PROJECT: Summerlin Village 24- Parcel COS-4

SUBMITTAL: 2nd Submittal

SUBJECT: Drainage Study for:
Summerlin Village 24 – Parcel COS-4

RESPONSE TO COMMENTS
ON THE
TECHNICAL DRAINAGE STUDY
FOR
SUMMERLIN VILLAGE 24
PARCEL COS-4 WASH

DRAWING
FIG-6R
OF SHTS

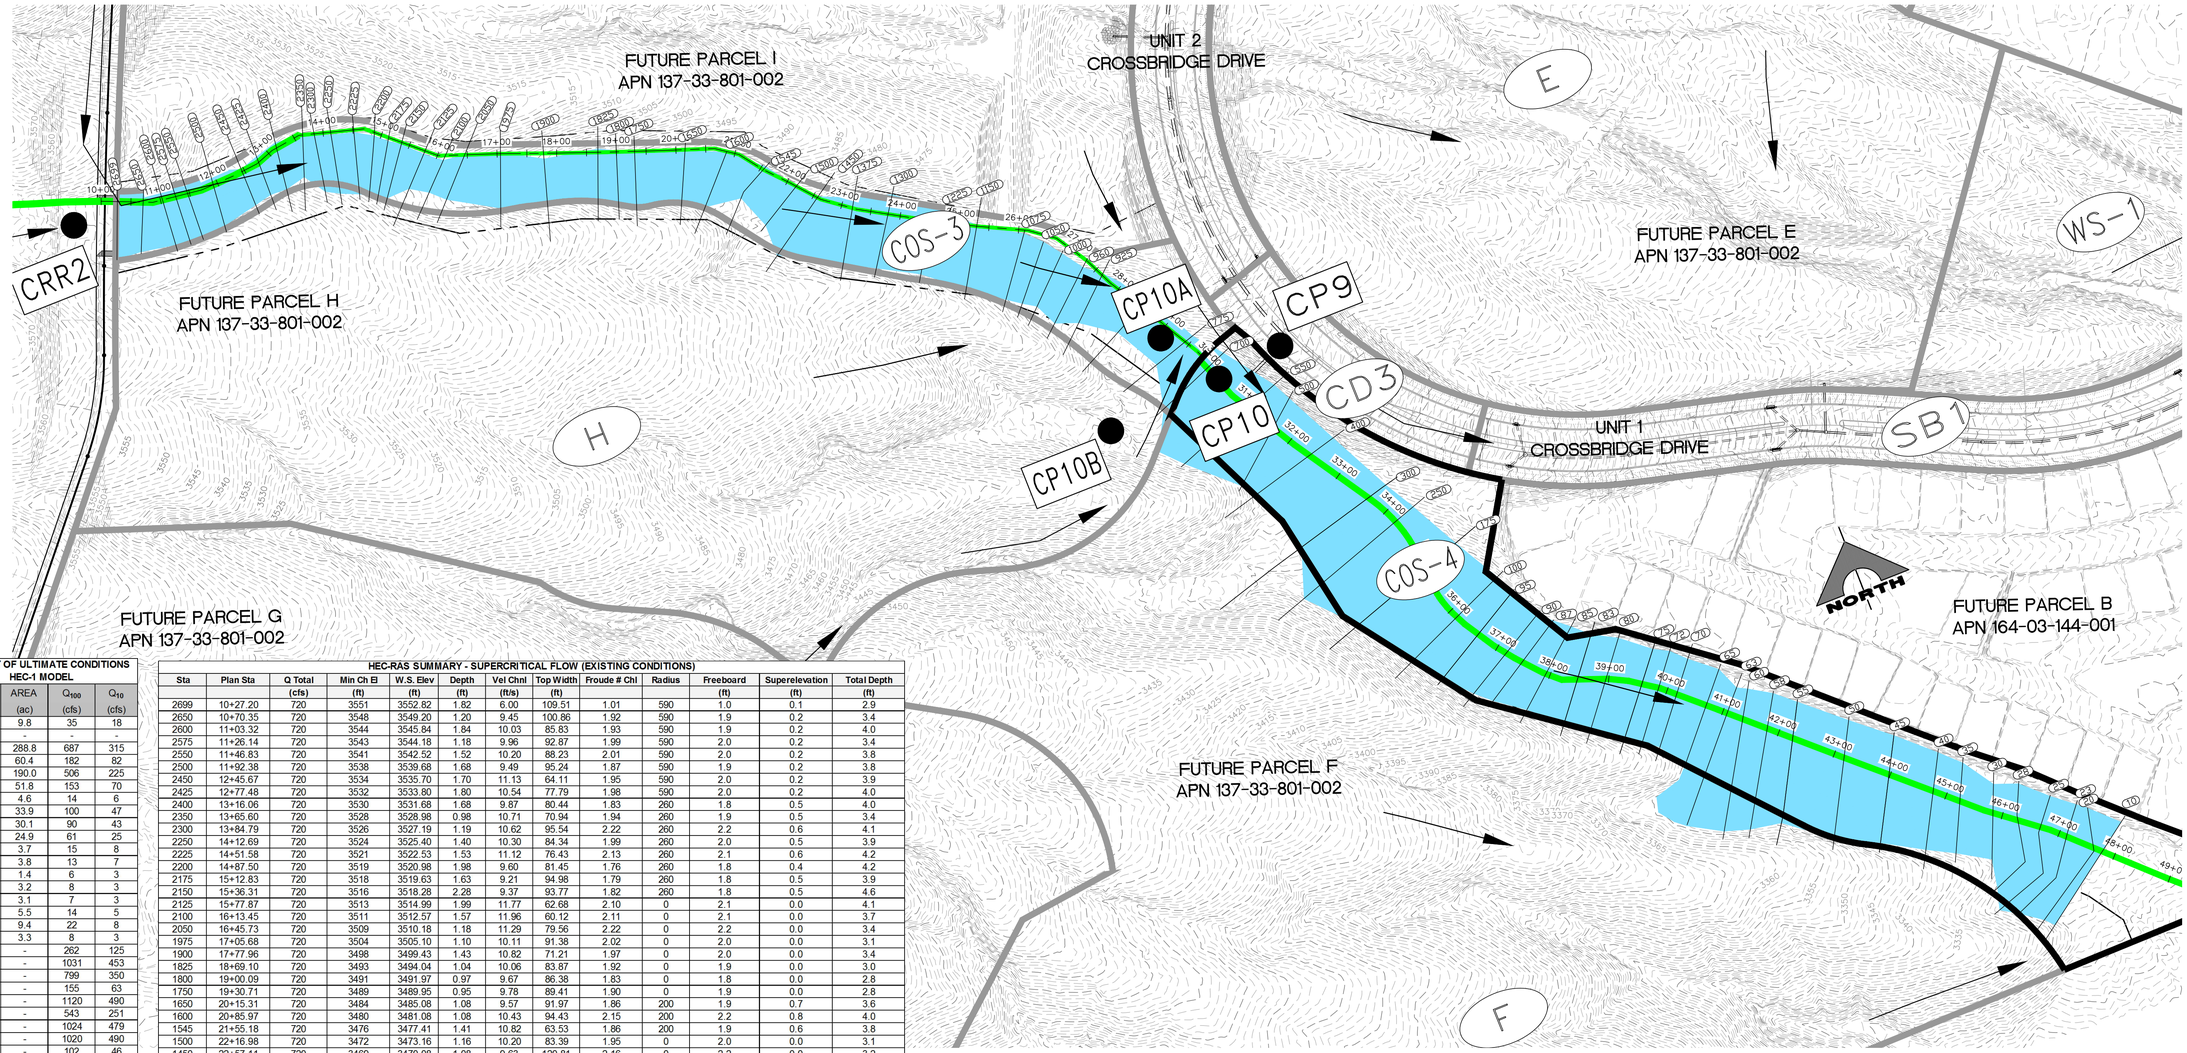
Please note that the alignment of the U.S. Waters has been corrected on Figures 6R and 7R. The corresponding stations correlating the hydraulic modeling stationing with the improvement plan U.S. Waters alignment stationing have been included in tables shown on Figures 6R and 7R. Although the alignment has been revised, the locations of the existing and proposed HEC-RAS cross sections remain unchanged. Copies of Figures 6R and 7R have been included in Appendix A.

DRAWING
FIG-7R
OF SHTS

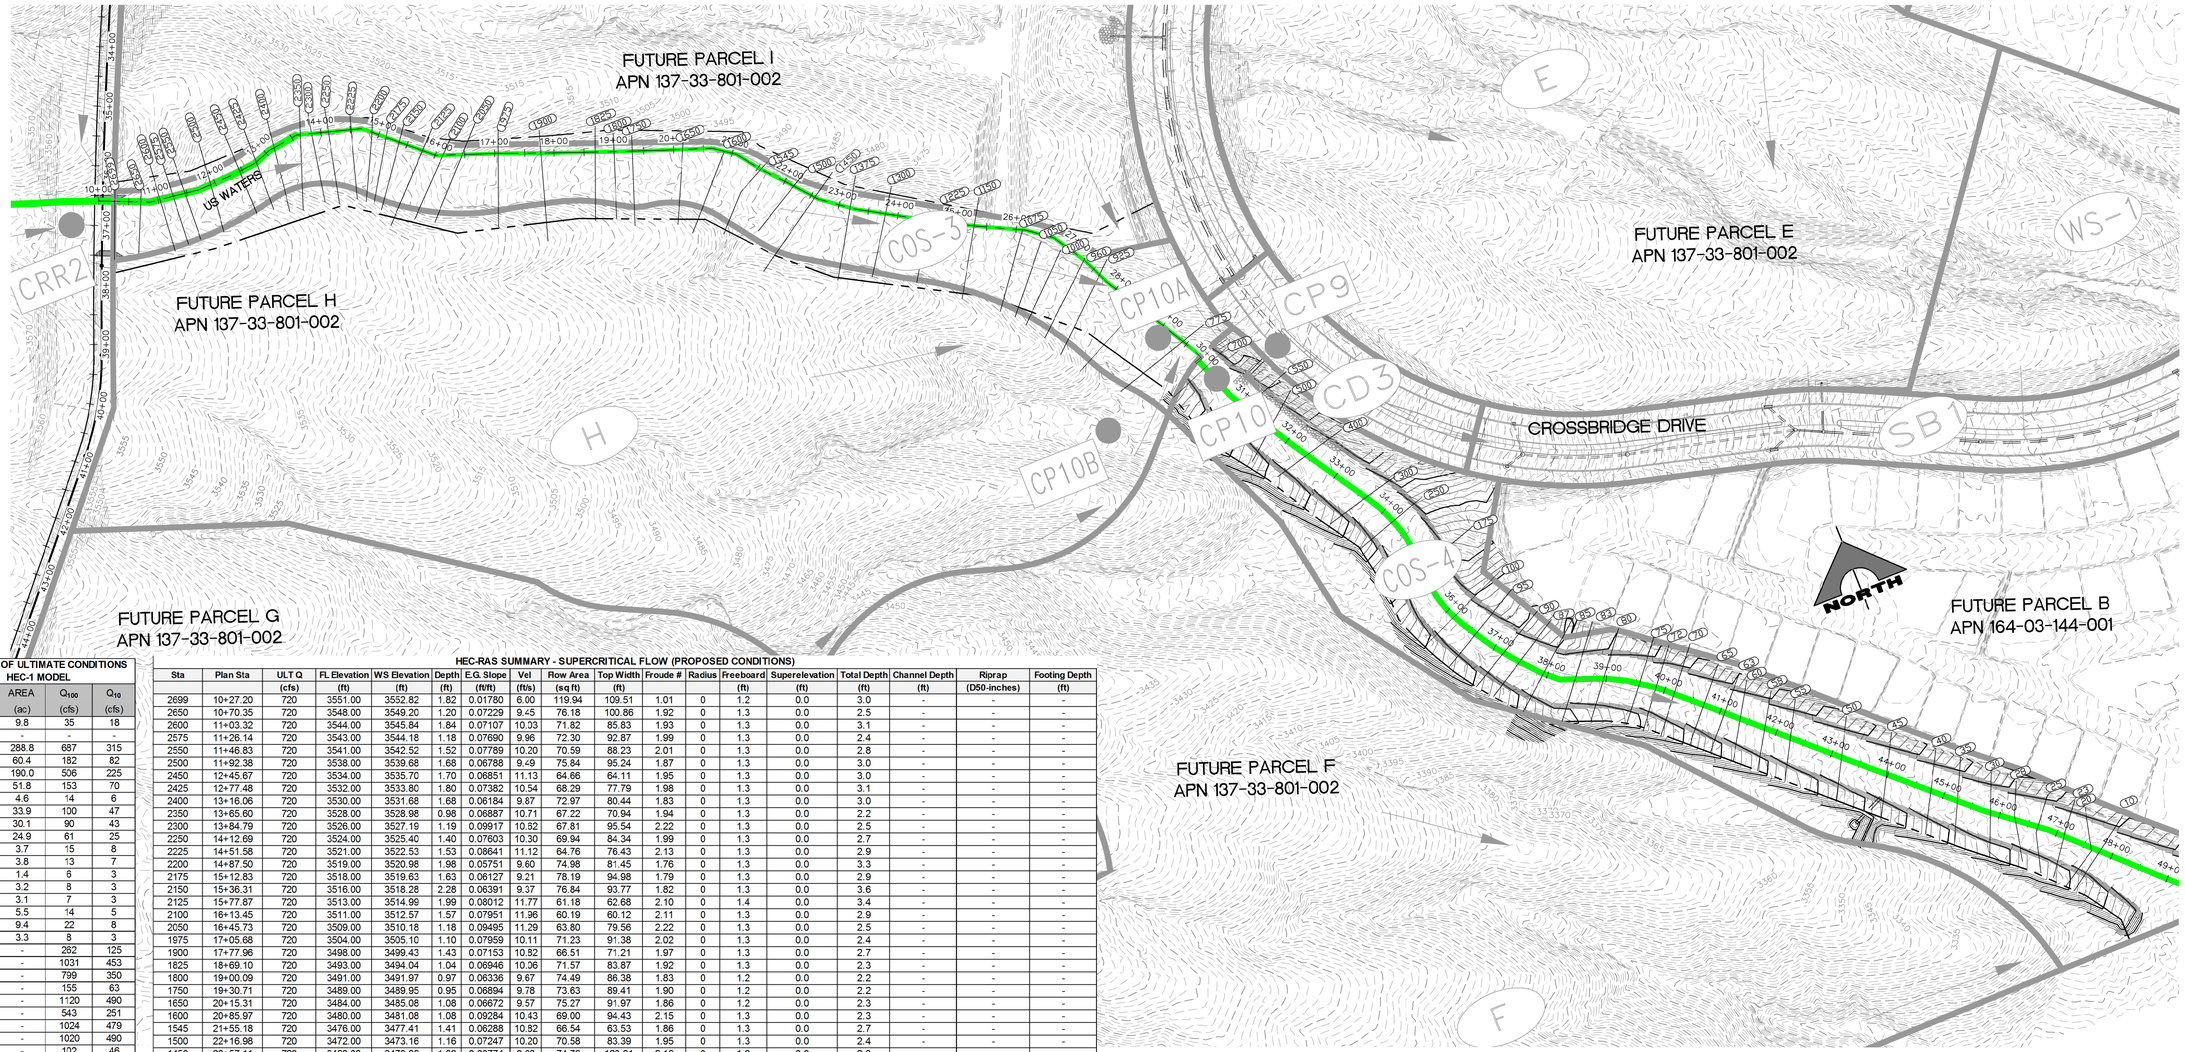
Comment: "3. **FIG-7 (Proposed Conditions HEC-RAS Exhibit):** A 48"-pipe culvert is proposed to discharge the drainage from future Parcel F at approximately between River Stations 45 and 50 into the wash. However, this additional discharge is not accounted in the *HEC-RAS Summary Table*. Address and resolve in the next submittal"

Response: Both the existing and ultimate conditions HEC-RAS models have been updated to show the increased flowrate of 1,120 cfs at Cross Section 45. The results of the revised models have been included in Tables shown on Figure 6R and Figure 7R. Copies of Figures 6R and 7R have been included in Appendix A. Copies of the revised HEC-RAS models (including digital files) have been included in Appendix B. Additionally, the scour calculations have been revised. The previously proposed 5-foot deep minimum vertical riprap cutoff wall is designed along the toe of the proposed channel improvements. Revised scour calculations have been included in Appendix B. The results of the calculations are summarized in Table 4R.
